Review of seismic-hazard issues associated with the Auburn Dam project, Sierra Nevada foothills, California

U.S. Geological Survey Open File Report 96-0011

SUMMARY

Figure 1. Map showing Auburn Dam site, traces of Foothills fault system (Jennings, 1994), and locations of other western Sierra dams (circles).

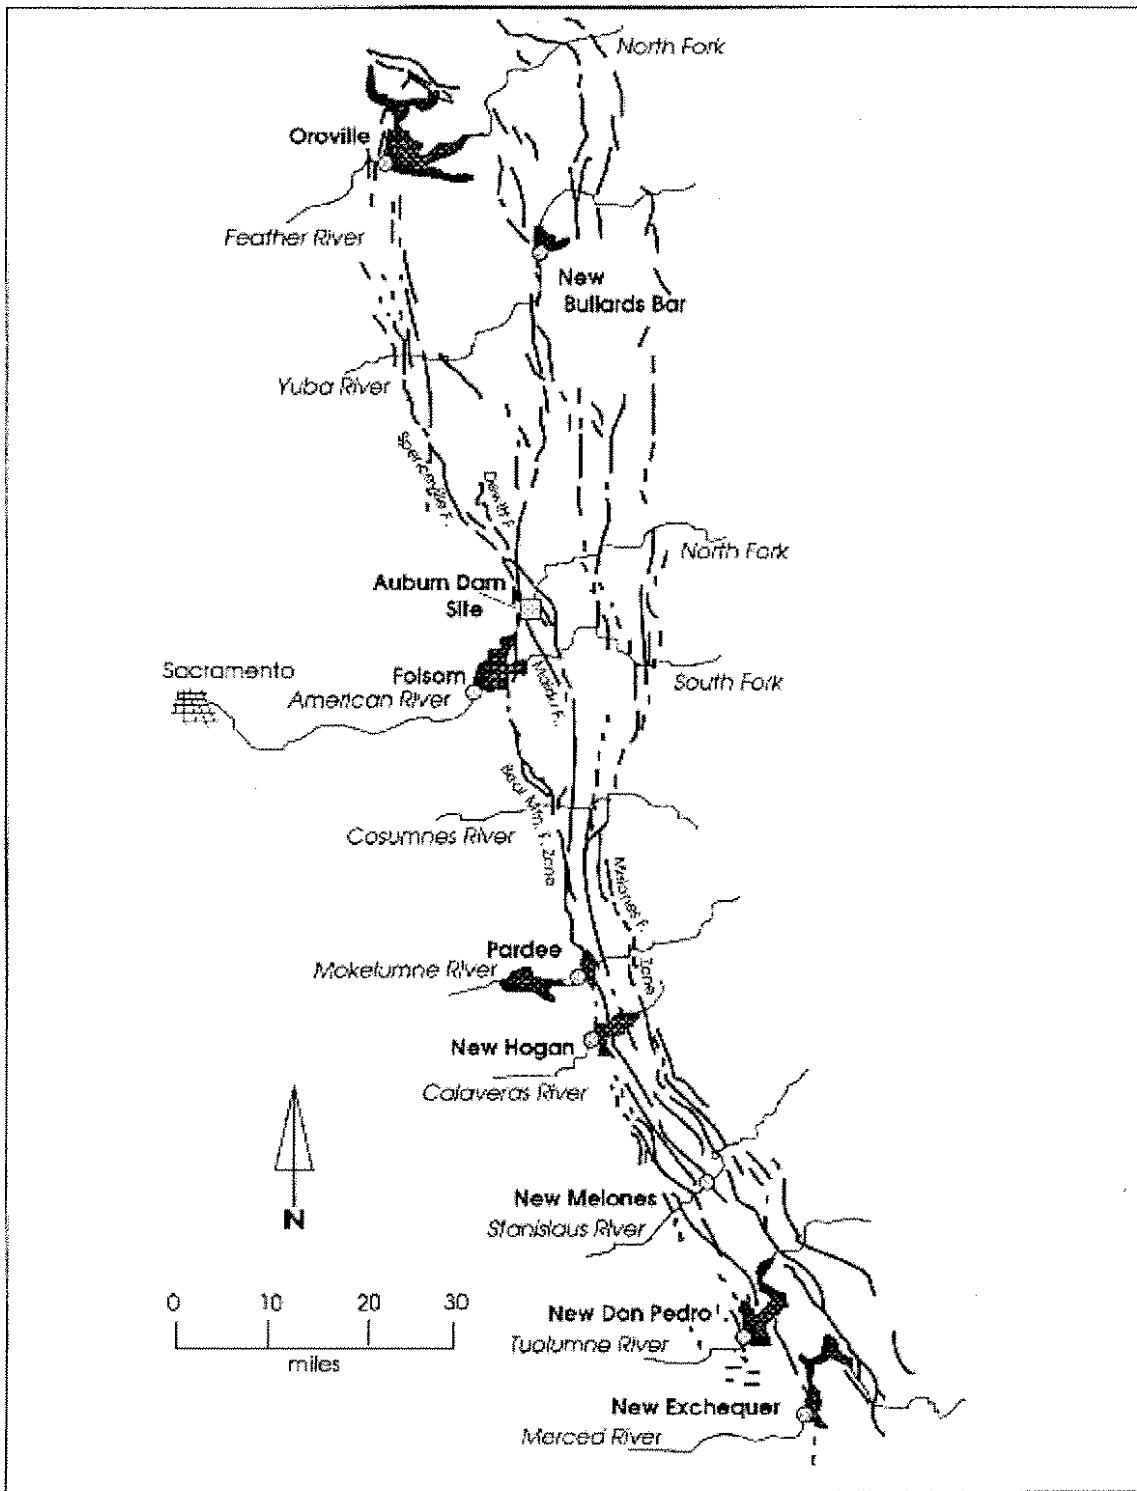
past 100,000 years. These new studies still do not clearly quantify the amount of displacement during individual surface faulting earthquakes, although trenches across the Dewitt fault (Figure 1) at a site six miles northwest of the Auburn Dam site exposed stratigraphic separation of a colluvium younger than the paleo B soil that can be interpreted, at this one location, as a single-event displacement of up to 40 cm (15 inches) (PG&E, 1994).

In seismic hazard investigations for the Rock Creek Dam PG&E (1994) estimated maximum earthquakes for faults in the Auburn area just north of the proposed Auburn Dam site. Using new field observations and estimates of displacement and fault length, and the updated statistical relations, they conclude that the maximum earthquake on the Spenceville fault (located eight miles northwest of Auburn, [Figure 1](#)) is 6.4 and the maximum earthquake on the Dewitt fault (located two miles northwest of Auburn at its closest approach, [Figure 1](#)) is 6.1 -6.3. For comparison we have used the Wells and

In summary, recent investigations of faults in the Foothills fault system show that cumulative late Quaternary displacements of 2 to 3 feet observed in soils and other geologic deposits are consistent with previous observations. These new field data continue to suggest that during the past 100,000 years displacement rates are low and displacements of a few tens of centimeters per event are reasonable estimates for many of the faults in the western Sierran foothills. However, neither the pre- nor post-1979 field data precisely define the maximum displacement per event. In 1979 a single value was selected for the maximum displacement. In present seismic hazard practice a strong effort is made to identify and incorporate uncertainty into design values. Therefore, alternative interpretations of field observations and alternative tectonic and fault behavior models can be considered, weighted, and combined to derive a design value and the uncertainty associated with it. There is a basis for estimating a range of potential maximum displacements at the Auburn Dam site, and a design value larger than 9 inches may need to be considered. We recommend that the design displacement be reevaluated.

Fig. 2. Seismicity before (left panel) and after (right panel) the impoundment of the Nurck reservoir. The outline of the full reservoir is shaded in both panels. Note that seismicity is concentrated near the reservoir following impoundment. From *Simpson and Negmatullaev* [1981].

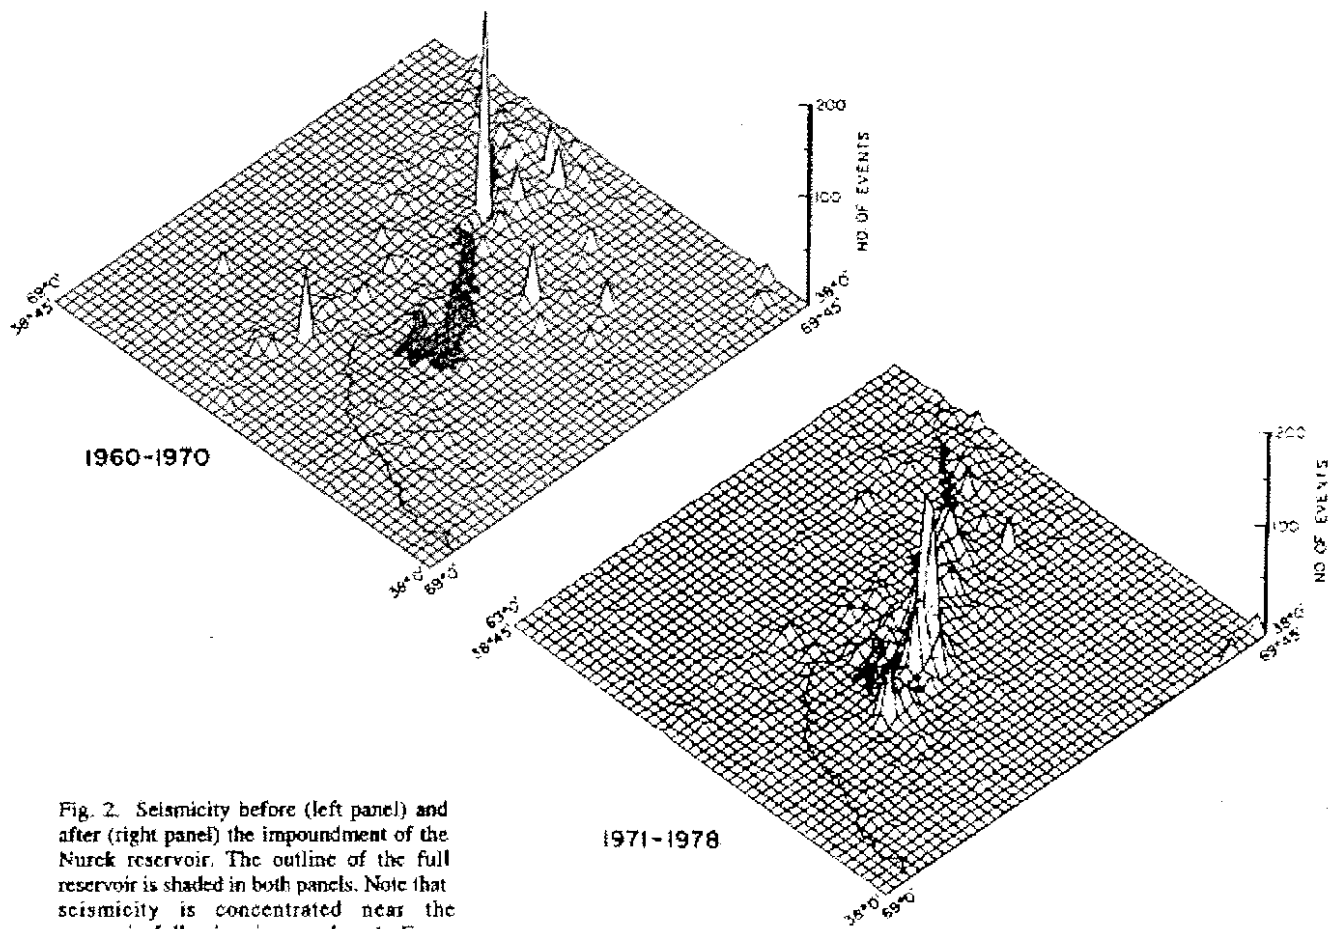
4. The probability of the occurrence of earthquakes at and in the region around a reservoir may be increased by impoundment. In a few of the best controlled studies where a reliable record of seismicity before and after reservoir impoundment exists (Segall, Grasso, and Mossop, 1994; Simpson and Negmatullaev, 1981), an increased rate of activity is seen within 10-15 km of impounded reservoirs and gas fields (Figure 2 and Figure 3/).

In summary, we conclude that reservoir-induced seismicity is an issue that will require additional analysis if the Auburn Dam project continues. There is a need to pursue development of approaches to calculate how reservoir impoundment may affect earthquake probabilities at the Auburn site and its environs. If the Auburn Dam Project is authorized, a dense seismic network should be installed around the Auburn Dam site as soon as possible to determine a baseline level of seismicity before impoundment. A downhole, three-component, wide-dynamic-range seismometer array could be very useful for this purpose. Additionally, borehole measurements of permeability, hydraulic head, and stress should be made in the vicinity before, during, and after impoundment.

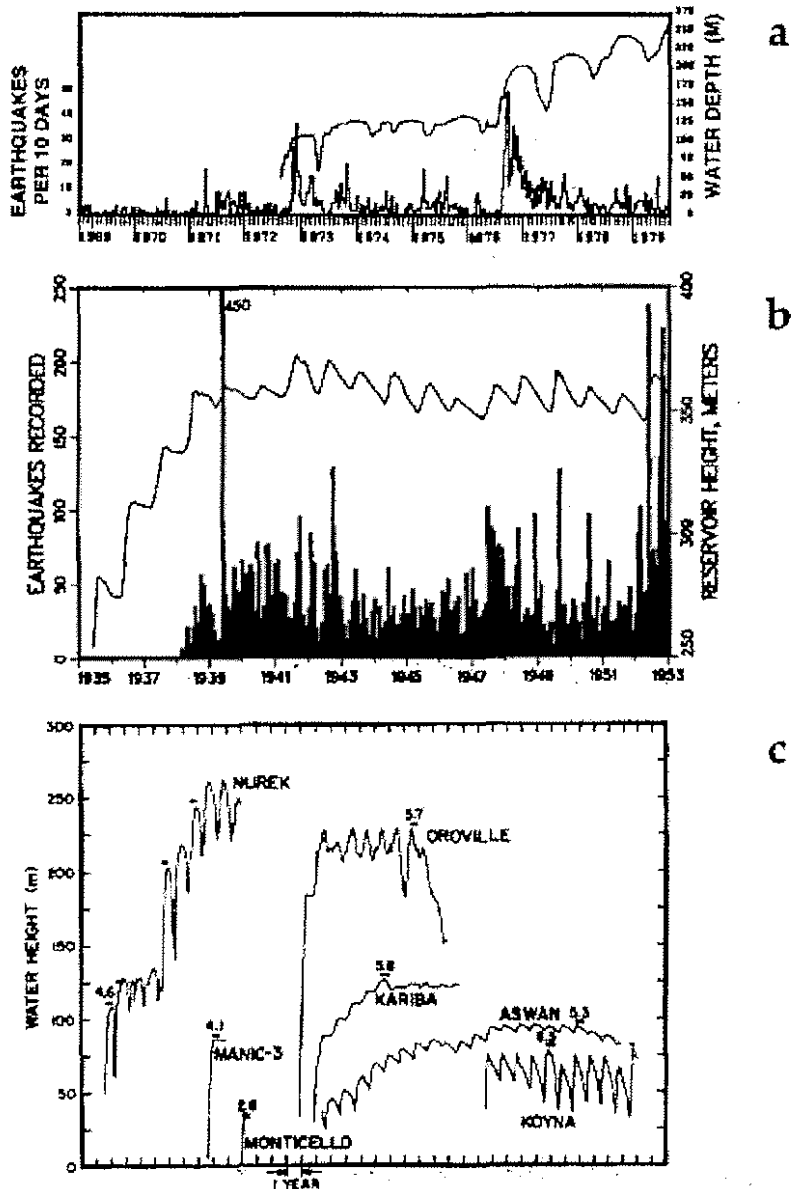
5. Observations point to a higher rate of earthquakes after reservoir impoundment, especially during the first decade (Anderson and O'Connell, 1993; Scholz, 1990; Simpson, 1986), although the relationship between impoundment time history and reservoir-induced seismicity is not consistent or well understood. In some cases reservoir induced seismicity has been observed shortly after the initiation of filling (Figure 3). For example, a magnitude 6.3 earthquake was induced by the Kremasta reservoir in Greece less than seven months after the initiation of filling in 1966 (Cominakis et al 1968). Alternatively, the Oroville earthquake, if reservoir induced, occurred ten years after reservoir impoundment.
